MEETING OF SOUTH DUBLIN COUNTY COUNCIL

Monday, July 12th, 2021

PART 8 REPORT

Killinarden Park Upgrade and Greenway between Killinarden Park and Sean Walsh Park in Tallaght, Dublin 24

Fig 2: Boundary Treatment Concept Plan

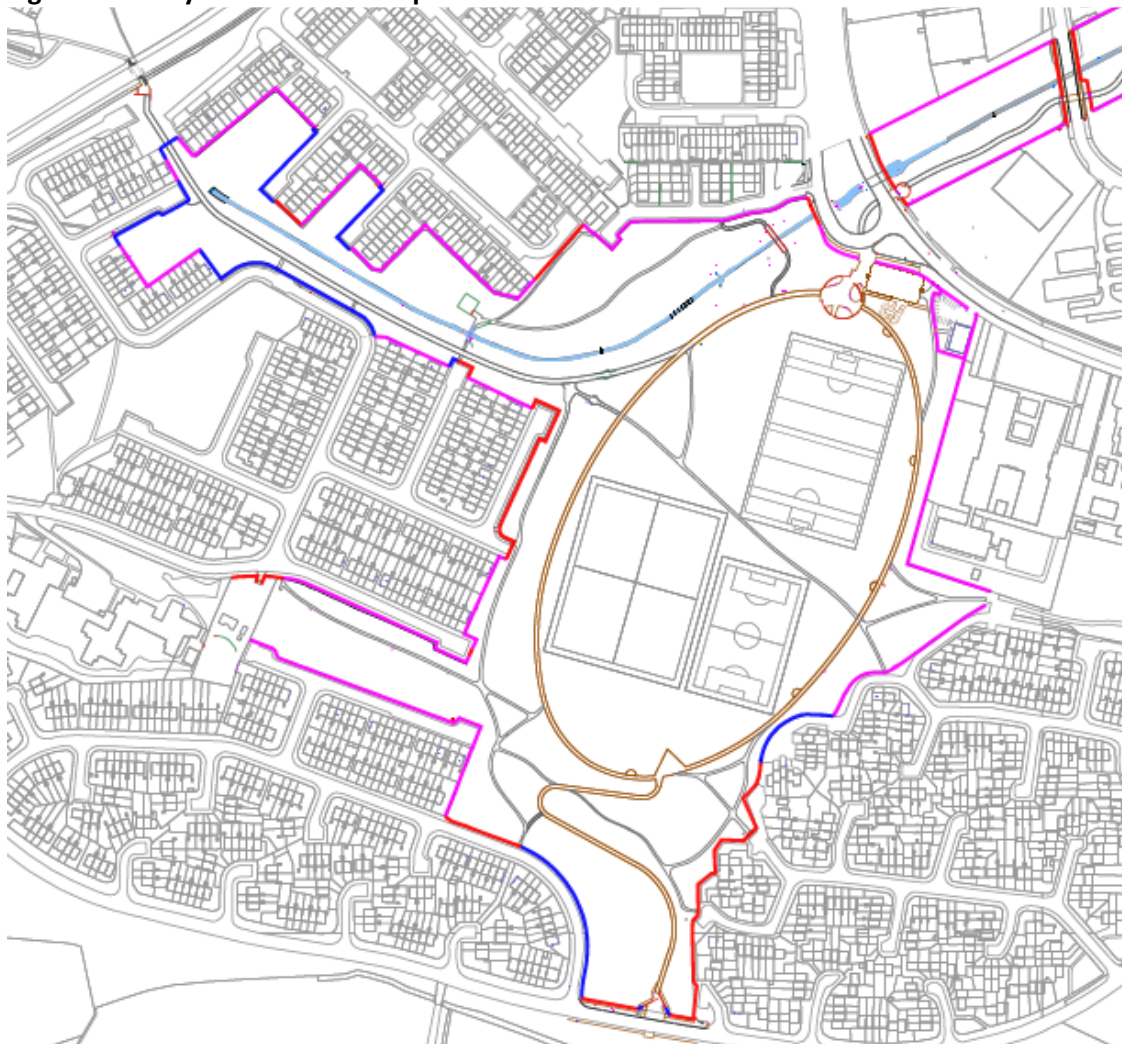
5. Greater security around pitches is supported. Suggested that the proposed areas around sporting pitches are very open with only small copse of trees. Advised that there is scope to add in more access controls, fencing, rock features, mature trees, mid-rise bow rail topped fencing and mounds that would protect pitches from cars, bikes and other damage.

8. Request from local GAA club for a pitch to be fenced off, in order to provide safety for players and school children to use, is supported. Reference is made to an incident of a scrambler bike speeding around GAA pitches, parents refusing to allow children to use Killinarden Park and absence of use of park. It is suggested that a pitch should be fenced off until intimidation from scrambler bike usage has dissipated.

In response to submissions, it is also recommended that modifications be made to the proposed development to include for natural landscape barriers around the GAA pitch. Furthermore, the level of the GAA pitch can be amended if required at detailed design.

Further to Section 5.2.1 of this report, these new boundaries will be integrated into the proposals to create a coherent and unified boundary around outer edges of Killinarden Park. As per the Boundary Treatment Concept Plan that accompanies the Part 8 proposal, this will include:

- Repair and upgrade existing boundaries where necessary (marked red on Fig. 2 above);
- Retain existing walls/railings that are in good condition (marked purple on Fig. 2 above); and
- Provide new boundary walls and railing, where required (marked blue on Fig. 2 above.).

Fig. 15 Cross Section of Greenway Illustrating Buffer Zone in Excess of 10 m from Stream

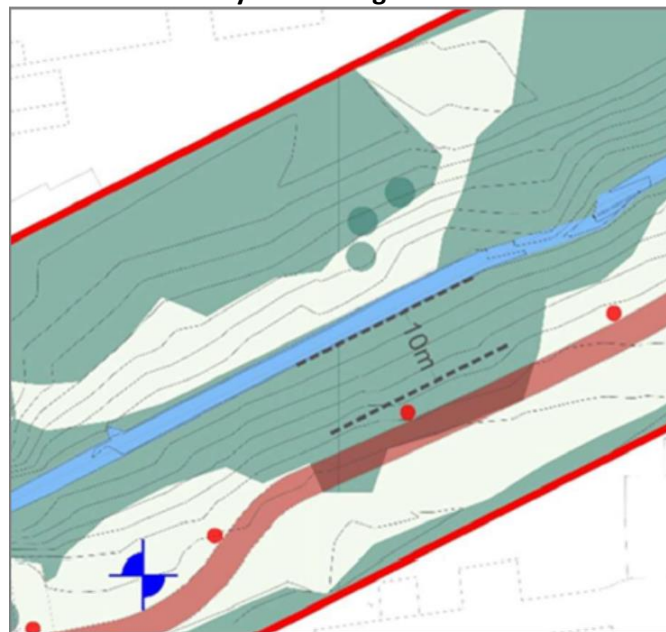
3. It is advised that the Whitestown Stream forms part of an ecological network that links green spaces and is an important a wildlife corridor for otters, bats, frogs, newts and well as species of birds, invertebrates and plants. It is also advised that the section of stream that flows through Tallaght and South City Business Parks was visited on 4th March and was found to be rich with native plants and has many native shrubs and trees, which are a source of food for insects, birds and mammals while also providing cover and nesting sites. Various species of bird were spotted. It is advised that steps should be taken including creating small areas of still water, creating small islands, planting native trees and planting hedgerows to attract a more diverse range of birds, insect, amphibian and insect species including pollinating insects. It is advised that there is a large amount of littering in the stream and opening it up would increase this. It is also advised that opening of the stream and the constructions of walkways would result in damage from human presence, excavation, loss of trees and plant cover, fragmentation and installation of lighting that would be detrimental to nocturnal species. It is requested that the corridor be retained as an ecological corridor that links wildlife to Sean Walshe Park and beyond with enhancement where possible.

In accordance with recent guidelines on *Planning for Watercourses in the Urban Environment* (Inland Fisheries Ireland, 2020), the Part 8 proposal will maintain a streamside riparian zone that is well in excess of the recommended 10 metres from the top of the bank of Whitestown Stream, apart from a small section located between the Whitestown Traveller Accommodation site and the stream.

Having been informed by the EclA and its proposed mitigation measures, it is also considered that this aspect of the proposal accords with G3 Objective 2 of the *South Dublin County Council Development Plan 2016 – 2022*, which seeks:
